Item 5.**Development Application: 32-38 Flinders Street, Darlinghurst**

File No.: D/2017/1731

Summary**Date of Submission:** 13 December 2017

Figure 15: Proposed roof plan

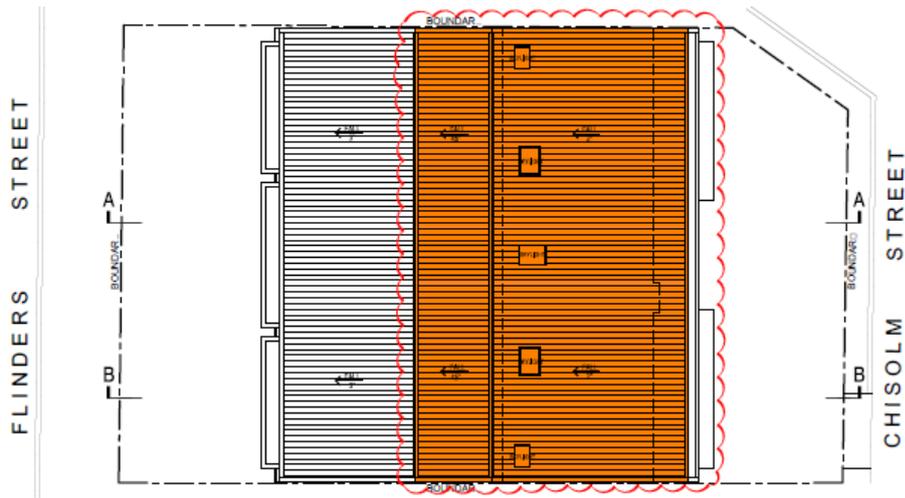
4B Natural Ventilation	Compliance	Comment
All habitable rooms are naturally ventilated.	Yes	<p>The design of the addition was revised following advice from the DAP and Urban Designers to include a skillion roof on the Flinders Street (west) elevation to reduce the bulk and massing of the addition. This resulted in the removal of the windows on the west elevation and the installation of rooflights instead.</p> <p>As a result, the apartments are single aspect but will achieve natural cross ventilation via openable rooflights. Three rooflights are proposed in the 1 bedroom apartment and 2 in the studio apartment. A rooflight will also be installed above the staircase to the apartments. A condition is recommended which requires details of the rooflights to be submitted to ensure that the rooflights are openable.</p>

Figure 16: Proposed west elevation fronting Flinders Street

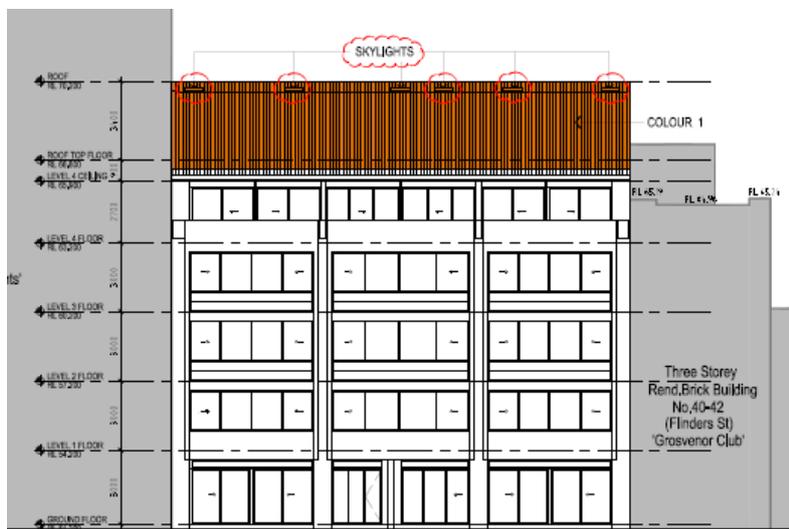
4.2.4 Fine grain, architectural diversity and articulation	Yes	The proposed addition includes a skillion roof on the west elevation and the detailing on the east elevation would match the existing building façade below.

50. The site is located within a Conservation Area and is therefore subject to the heritage provisions of the Sydney LEP and DCP. The proposal was amended following comments from Heritage Specialists and the Design Advisory Panel. A skillion roof to match the existing was added to the elevation facing Flinders Street to reduce visibility of the addition from Linden Lane and long views from Flinders Street. The rear façade of the addition and the unit 1 terrace was revised to match the modulated façade of the existing building which picks up proportions from nearby terraces.
51. The revised proposal is supported in principle by Council's Heritage Specialist and Urban Designer. The proposal is considered to preserve the heritage significance of the conservation area and is consistent with the objectives of clause 5.10 of the LEP and provision 3.9.5 of the DCP.

Figure 21: Section A-A through the existing building and proposed addition showing the 15m height limit.

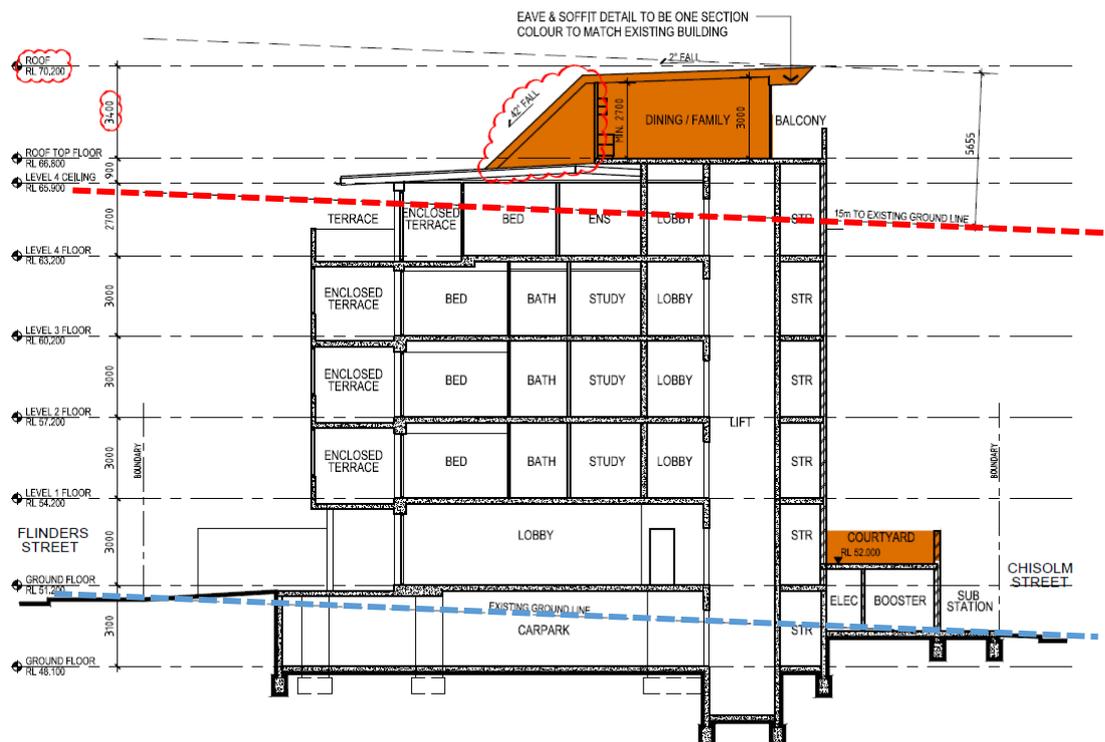
39. The site is subject to a 15m height control under the Sydney LEP. The proposed additional storey will increase the maximum height of the building to 20.8m. This represents a 5.8m or 38.7% variation to the building height development standard. It is noted that the existing building currently exceeds the maximum LEP height control.
40. The ground level falls across the site from RL 50.76 on Flinders Street to RL 49.29 on Chisholm Street. Figure 21 below shows the 15m height limit and the elements of the existing building and proposed addition above the building height standard.
